AGENDA
REGULAR MEETING OF THE BIRMINGHAM PLANNING BOARD
WEDNESDAY SEPTEMBER 27, 2023 – 7:30 PM
151 MARTIN ST., CITY COMMISSION ROOM 205, BIRMINGHAM MI*

SUBJECT: 380 S. Bates – Community House – Community Impact Study & Preliminary Site Plan Review

Zoning Compliance Summary Sheet
Community Impact Study & Preliminary Site Plan Review
380 S. Bates – Community House

DUMPSTER ENCLOSURE DETAIL
N.T.S.

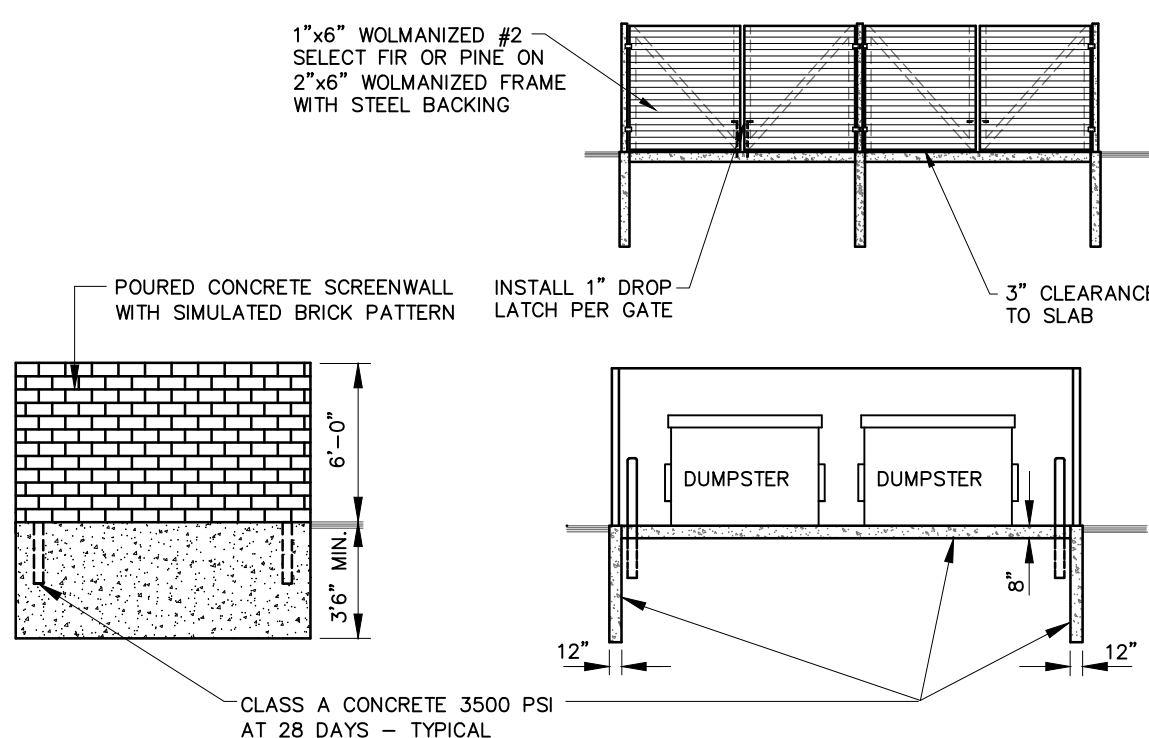
The CIS and site plans submitted a dedicated trash enclosure on the west side of the property along Chester. The CIS states, and the site plans confirm, that the applicant will be providing space to separate trash and recycling for pickup. The applicant feels as though the site will produce a "normal" level of waste and that it will be able to be handled by ordinary trash collection procedures. It is worth noting, however, that the existing trash receptacle on site appears to be a compactor located within a shed type structure with gates. The compactor is tall, and significantly taller than the gates for the enclosure in which it is located. The elevation drawings for the addition appear to show a standard 6 ft. high masonry screenwall with gates, which suggests that ordinary top-loading dumpster may be proposed as a part of this development. With the additional square footage, and the additional waste that could be reasonably assumed that it will produce, the change from a large compactor to two ordinary dumpsters (one for trash, one for recycling) may be problematic. If the solution is increased pickup scheduling, that could also prove to be problematic based on the location of the waste collection area. **The Planning Board should request that the applicant confirm and explain the strategy for solid waste at this site.**

5. The Planning Board should request that the applicant confirm and explain the strategy for solid waste at this site;
6. The applicant must submit a completed Transportation Impact Study for final review by the City; and
